# Product Change Notification

## **Bourns® Model FW, W, and WS Series Fixed Resistors**

### **Change to Packaging Dimensions/Tolerances of the Carrier Tape and Packaging Box**

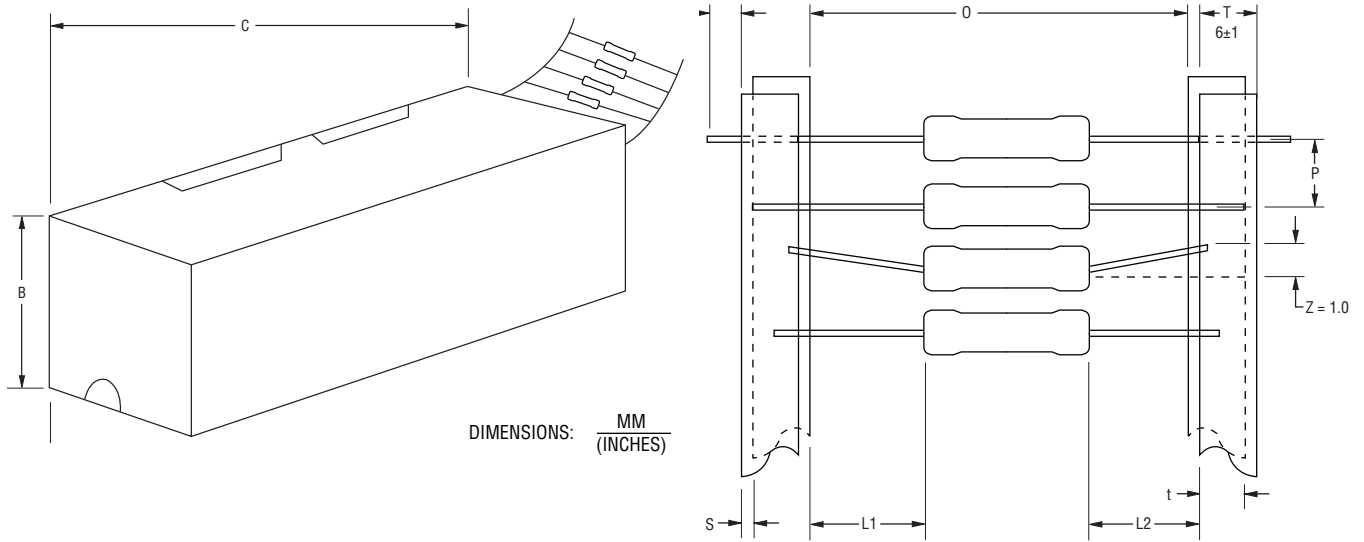
The Bourns® Model **FW**, **W**, and **WS** Series Fixed Resistors packaging dimensions/tolerances of the carrier tape and packaging box have changed. The specific dimensional changes and affected part numbers are listed on pages 2-5 of this notice.

#### Original Dimensions - FW Series

Model	O	P	A	B	C	Qty./Box
FW10A (1 W)	$\frac{52 \pm 1}{(2.047 \pm .039)}$	$\frac{5 \pm 0.3}{(.197 \pm .112)}$	$\frac{75 \pm 5}{(2.953 \pm .197)}$	$\frac{70 \pm 5}{(2.756 \pm .197)}$	$\frac{255 \pm 5}{(10.039 \pm .197)}$	1,000 pcs.
FW20A (2 W)	$\frac{58 \pm 1}{(2.283 \pm .039)}$	$\frac{5 \pm 0.3}{(.197 \pm .112)}$	$\frac{80 \pm 5}{(3.150 \pm .197)}$	$\frac{82 \pm 5}{(3.228 \pm .197)}$	$\frac{255 \pm 5}{(10.039 \pm .197)}$	1,000 pcs.
FW30A (3 W)	$\frac{65 \pm 1}{(2.559 \pm .039)}$	$\frac{10 \pm 0.3}{(.393 \pm .112)}$	$\frac{90 \pm 5}{(3.543 \pm .197)}$	$\frac{119 \pm 5}{(4.685 \pm .197)}$	$\frac{255 \pm 5}{(10.039 \pm .197)}$	1,000 pcs.
FW50A (5 W)	$\frac{65 \pm 1}{(2.559 \pm .039)}$	$\frac{10 \pm 0.3}{(.393 \pm .112)}$	$\frac{90 \pm 5}{(3.543 \pm .197)}$	$\frac{88 \pm 5}{(3.465 \pm .197)}$	$\frac{255 \pm 5}{(10.039 \pm .197)}$	500 pcs.
FW70A (7 W)	$\frac{65 \pm 1}{(2.559 \pm .039)}$	$\frac{10 \pm 0.3}{(.393 \pm .112)}$	$\frac{90 \pm 5}{(3.543 \pm .197)}$	$\frac{88 \pm 5}{(3.465 \pm .197)}$	$\frac{255 \pm 5}{(10.039 \pm .197)}$	500 pcs.

#### New Dimensions - FW Series

Model	O	P	A	B	C	Qty./Box
FW10A (1 W)	$\frac{52 \pm 1}{(2.047 \pm .039)}$	$\frac{5 \pm 0.3}{(.197 \pm .012)}$	$\frac{75 \pm 5}{(2.953 \pm .197)}$	$\frac{70 \pm 5}{(2.756 \pm .197)}$	$\frac{255 \pm 5}{(10.039 \pm .197)}$	1,000 pcs.
FW20A (2 W)	$\frac{58 \pm 1}{(2.283 \pm .039)}$	$\frac{10 \pm 0.5}{(.394 \pm .020)}$	$\frac{90 \pm 5}{(3.543 \pm .197)}$	$\frac{119 \pm 5}{(4.685 \pm .197)}$	$\frac{255 \pm 5}{(10.039 \pm .197)}$	1,000 pcs.
FW30A (3 W)	$\frac{65 \pm 5}{(2.559 \pm .197)}$	$\frac{10 \pm 0.5}{(.394 \pm .020)}$	$\frac{90 \pm 5}{(3.543 \pm .197)}$	$\frac{119 \pm 5}{(4.685 \pm .197)}$	$\frac{255 \pm 5}{(10.039 \pm .197)}$	1,000 pcs.
FW50A (5 W)	$\frac{65 \pm 5}{(2.559 \pm .197)}$	$\frac{10 \pm 0.5}{(.394 \pm .020)}$	$\frac{90 \pm 5}{(3.543 \pm .197)}$	$\frac{88 \pm 5}{(3.465 \pm .197)}$	$\frac{255 \pm 5}{(10.039 \pm .197)}$	500 pcs.
FW70A (7 W)	$\frac{90 \pm 5}{(3.543 \pm .197)}$	$\frac{10 \pm 0.5}{(.394 \pm .020)}$	$\frac{90 \pm 5}{(3.543 \pm .197)}$	$\frac{124 \pm 5}{(4.882 \pm .197)}$	$\frac{500 \pm 5}{(19.685 \pm .197)}$	500 pcs.

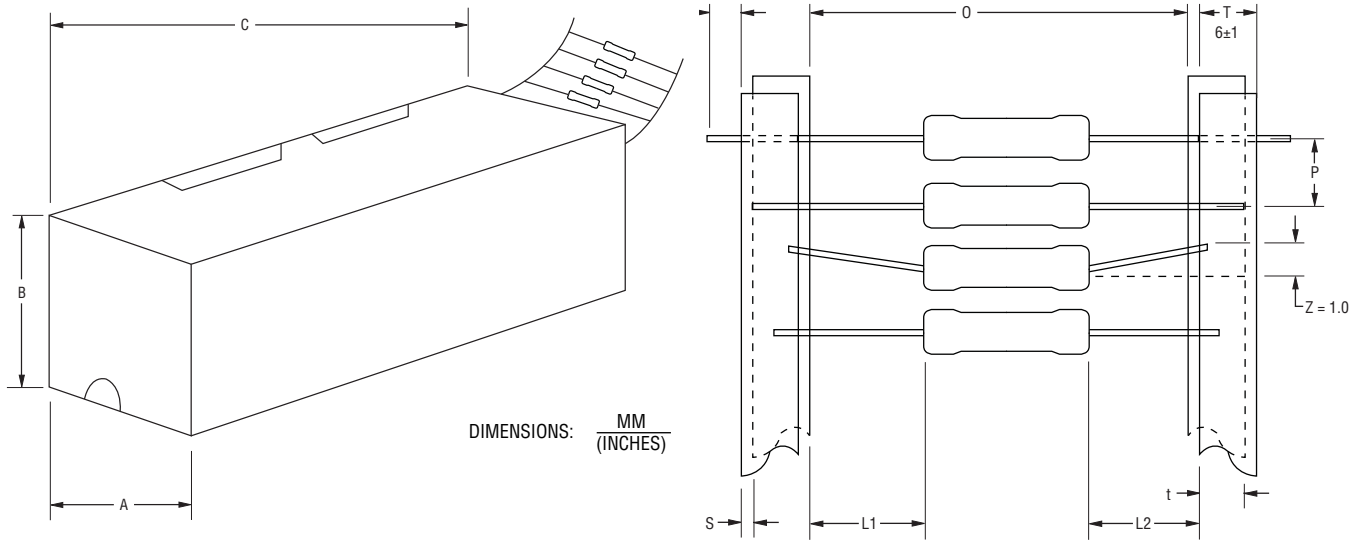
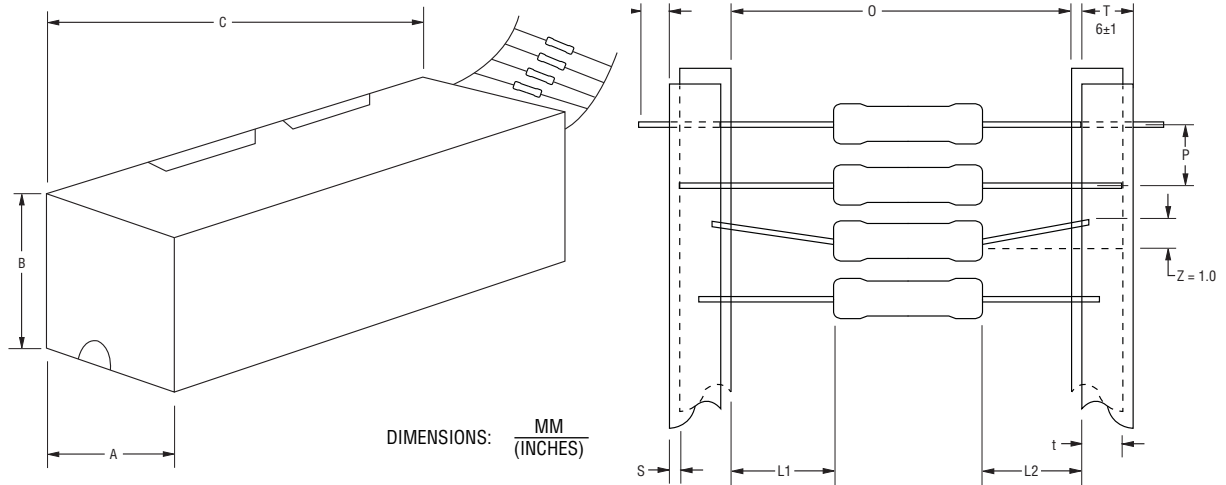
#### Original Dimensions - W Series

Model	O	P	A	B	C	Qty./Box
W1M	$\frac{58 \pm 1}{(2.283 \pm .039)}$	$\frac{5 \pm 0.3}{(.197 \pm .112)}$	$\frac{75 \pm 5}{(2.953 \pm .197)}$	$\frac{70 \pm 5}{(2.756 \pm .197)}$	$\frac{255 \pm 5}{(10.039 \pm .197)}$	1,000 pcs.
W2M	$\frac{58 \pm 1}{(2.283 \pm .039)}$	$\frac{5 \pm 0.3}{(.197 \pm .112)}$	$\frac{80 \pm 5}{(3.150 \pm .197)}$	$\frac{82 \pm 5}{(3.228 \pm .197)}$	$\frac{255 \pm 5}{(10.039 \pm .197)}$	1,000 pcs.
W3M	$\frac{65 \pm 5}{(2.559 \pm .197)}$	$\frac{10 \pm 0.3}{(.393 \pm .112)}$	$\frac{90 \pm 5}{(3.543 \pm .197)}$	$\frac{119 \pm 5}{(4.685 \pm .197)}$	$\frac{255 \pm 5}{(10.039 \pm .197)}$	1,000 pcs.
W5M	$\frac{65 \pm 5}{(2.559 \pm .197)}$	$\frac{10 \pm 0.3}{(.393 \pm .112)}$	$\frac{90 \pm 5}{(3.543 \pm .197)}$	$\frac{88 \pm 5}{(3.465 \pm .197)}$	$\frac{255 \pm 5}{(10.039 \pm .197)}$	500 pcs.
W7M	$\frac{90 \pm 5}{(3.543 \pm .197)}$	$\frac{10 \pm 0.3}{(.393 \pm .112)}$	$\frac{115 \pm 5}{(4.528 \pm .197)}$	$\frac{124 \pm 5}{(4.882 \pm .197)}$	$\frac{500 \pm 5}{(19.685 \pm .197)}$	500 pcs.

#### New Dimensions - W Series

Model	O	P	A	B	C	Qty./Box
W1M	$\frac{58 \pm 1}{(2.283 \pm .039)}$	$\frac{5 \pm 0.3}{(.197 \pm .112)}$	$\frac{75 \pm 5}{(2.953 \pm .197)}$	$\frac{70 \pm 5}{(2.756 \pm .197)}$	$\frac{255 \pm 5}{(10.039 \pm .197)}$	1,000 pcs.
W2M	$\frac{58 \pm 1}{(2.283 \pm .039)}$	$\frac{10 \pm 0.5}{(.394 \pm .020)}$	$\frac{80 \pm 5}{(3.150 \pm .197)}$	$\frac{82 \pm 5}{(3.228 \pm .197)}$	$\frac{255 \pm 5}{(10.039 \pm .197)}$	1,000 pcs.
W3M	$\frac{65 \pm 5}{(2.559 \pm .197)}$	$\frac{10 \pm 0.5}{(.394 \pm .020)}$	$\frac{90 \pm 5}{(3.543 \pm .197)}$	$\frac{119 \pm 5}{(4.685 \pm .197)}$	$\frac{255 \pm 5}{(10.039 \pm .197)}$	1,000 pcs.
W5M	$\frac{65 \pm 5}{(2.559 \pm .197)}$	$\frac{10 \pm 0.5}{(.394 \pm .020)}$	$\frac{90 \pm 5}{(3.543 \pm .197)}$	$\frac{88 \pm 5}{(3.465 \pm .197)}$	$\frac{255 \pm 5}{(10.039 \pm .197)}$	500 pcs.
W7M	$\frac{90 \pm 5}{(3.543 \pm .197)}$	$\frac{10 \pm 0.5}{(.394 \pm .020)}$	$\frac{115 \pm 5}{(4.528 \pm .197)}$	$\frac{124 \pm 5}{(4.882 \pm .197)}$	$\frac{500 \pm 5}{(19.685 \pm .197)}$	500 pcs.
